CCPS RFP # 24-09 – Perryville High School – New Field House Project

ADDENDUM #2

This addendum is to answer questions asked during the question period which ended November 30, 2023. Proposers and related parties will be responsible to have read and understand all documents, the scope of work, addenda and all related solicitation documents issued. These documents will become attached to and part of the solicitation and award of bid contract.

DATE: 11/03/2023
SCALE: AS NOTED
DRAWN BY: CK, AH
CHECKED BY: VS
DRAWING NO: G1
PWA JOB NUMBER: 2181073.00

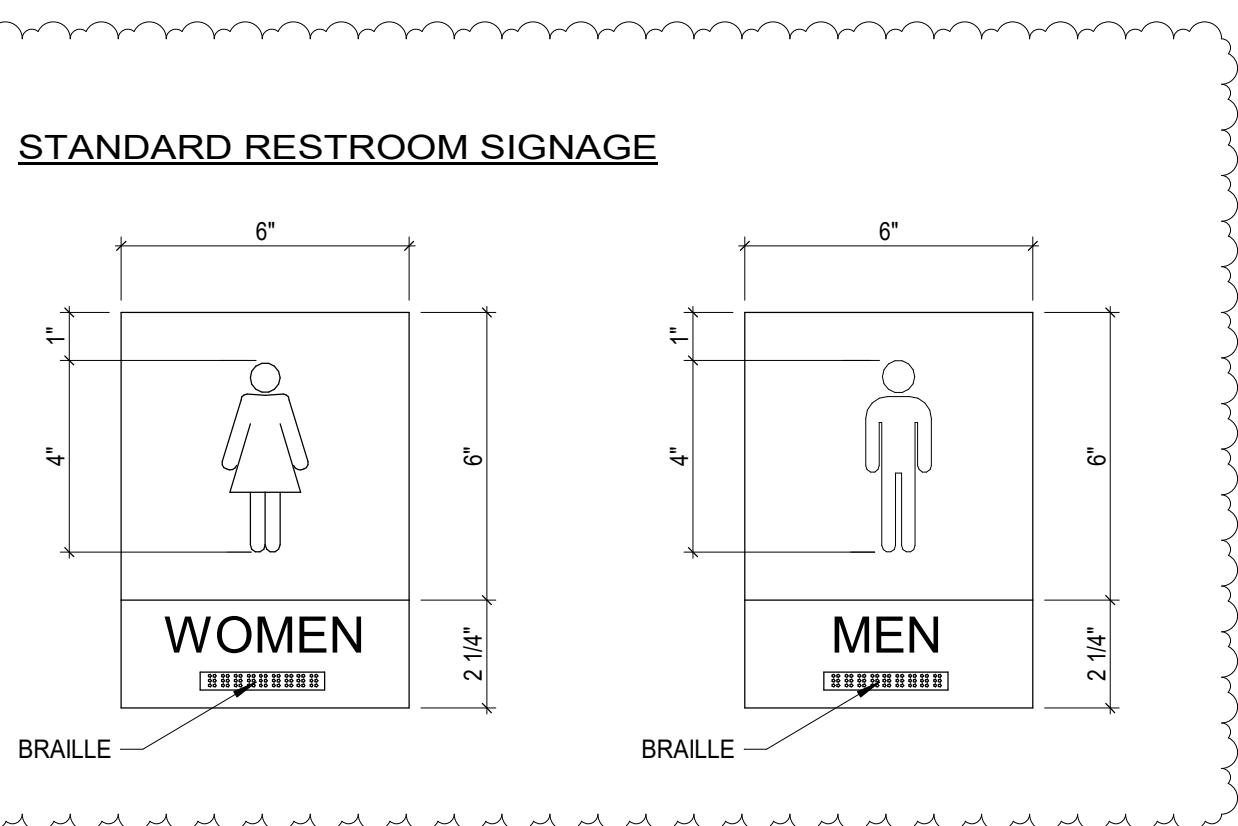
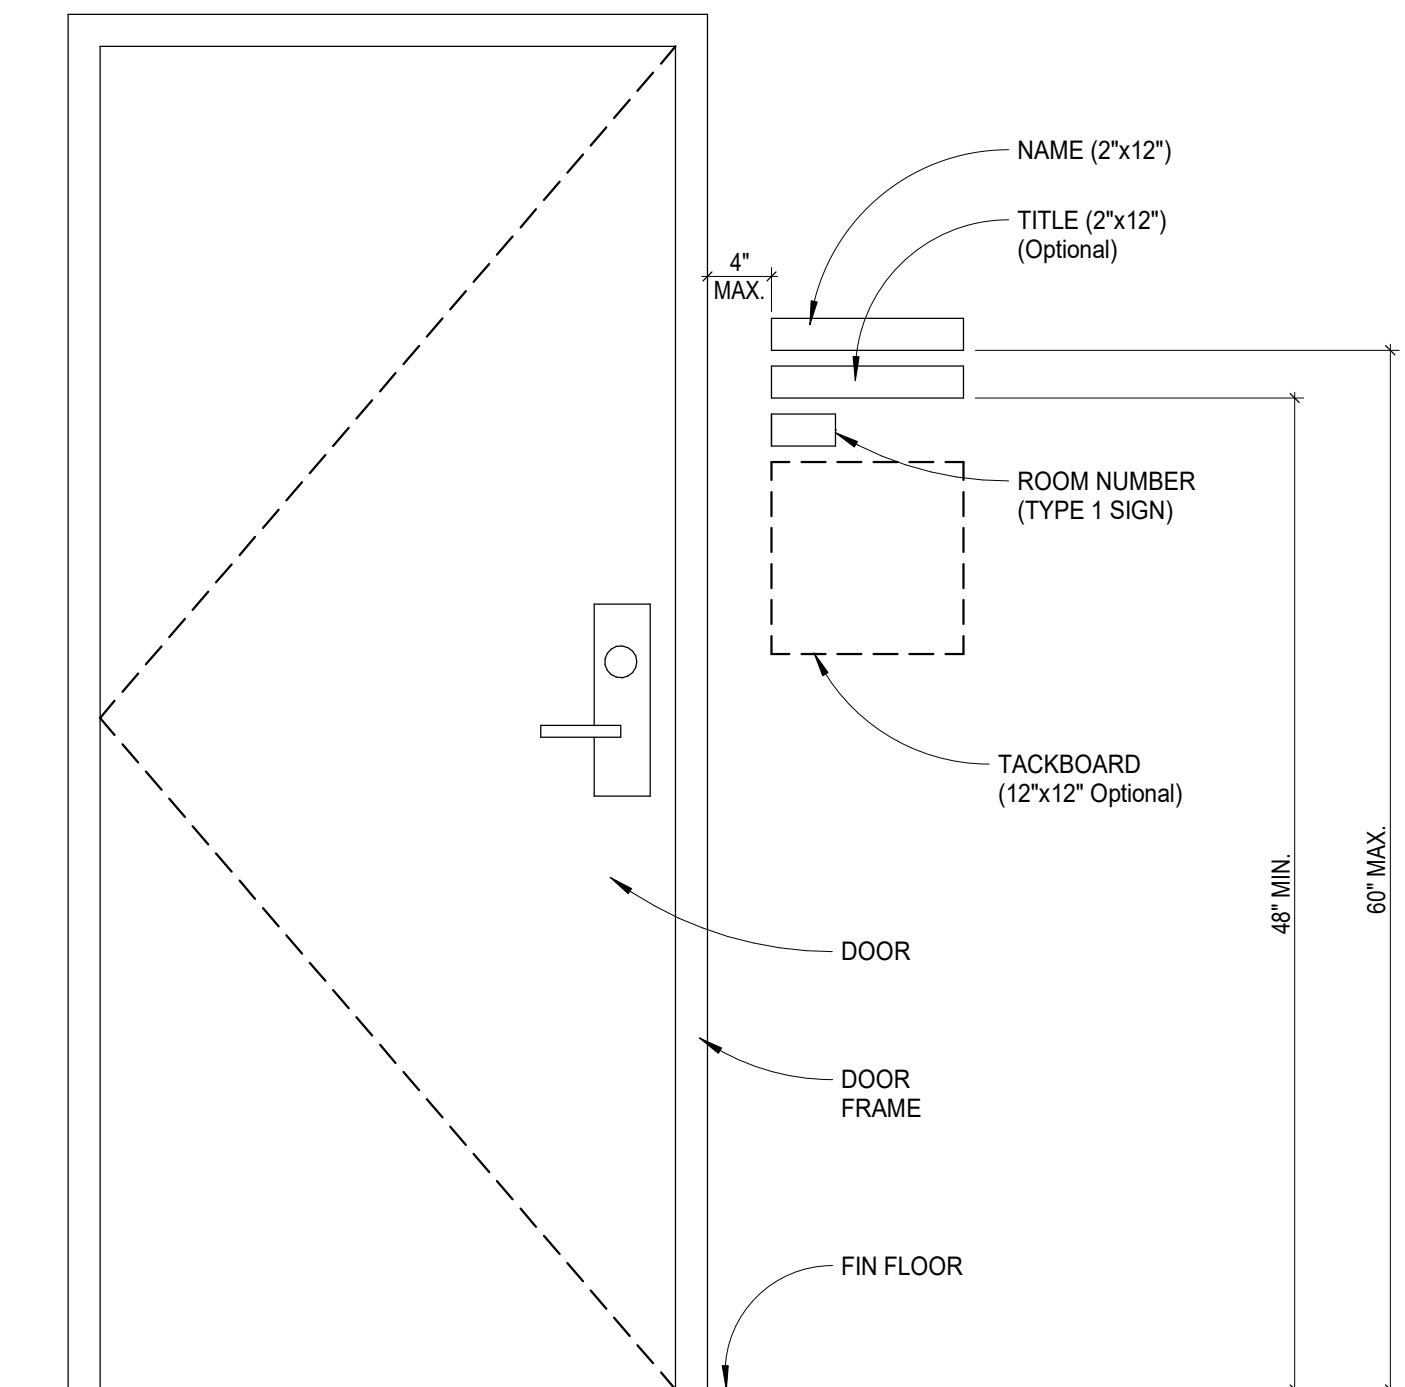
G1 - In response to Question #20, signage details have been updated to include Braille detail.

QUESTION 20: The Men and Women's standard signage detail has no handicap or braille detail. Please confirm this detail is correct.

ANSWER 20: See revised drawing sheet G1. Signage detail has been updated to include Braille detail.

2 REFLECTED CEILING PLAN
1/8" = 1'-0"

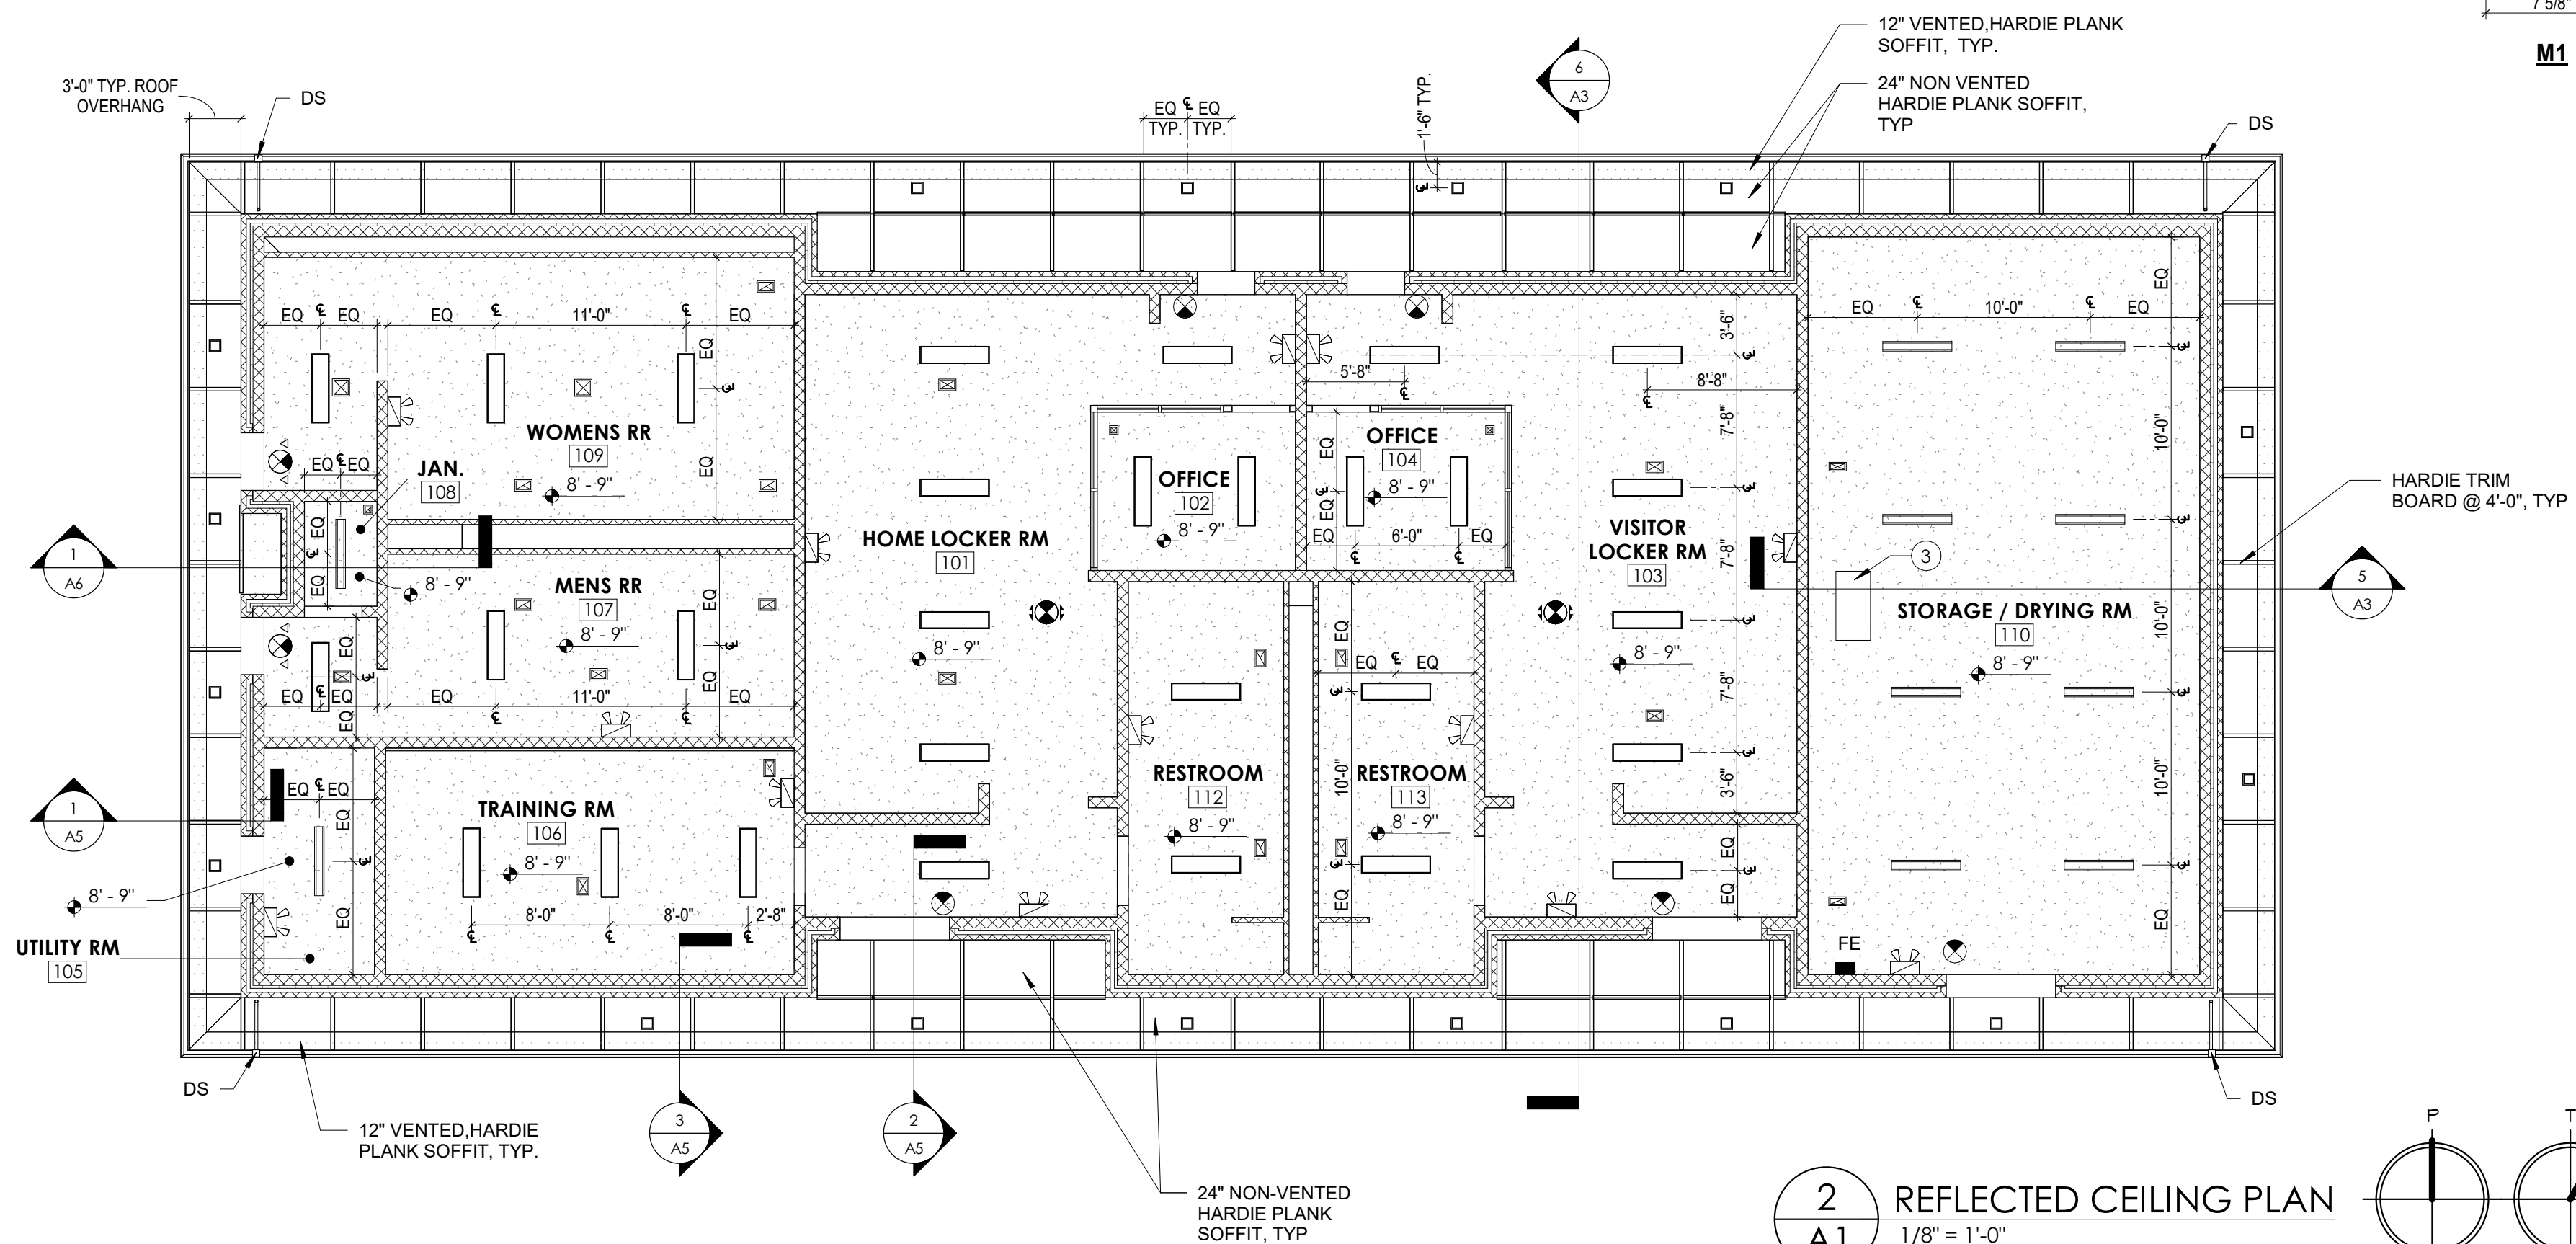
QUESTION 26: Please provide the orientation and spacing of the batten board specified in section 074646.

ANSWER 26: See Reflected Ceiling Plan (Detail 2/A1) for information on orientation and spacing of batten trim board at soffit.
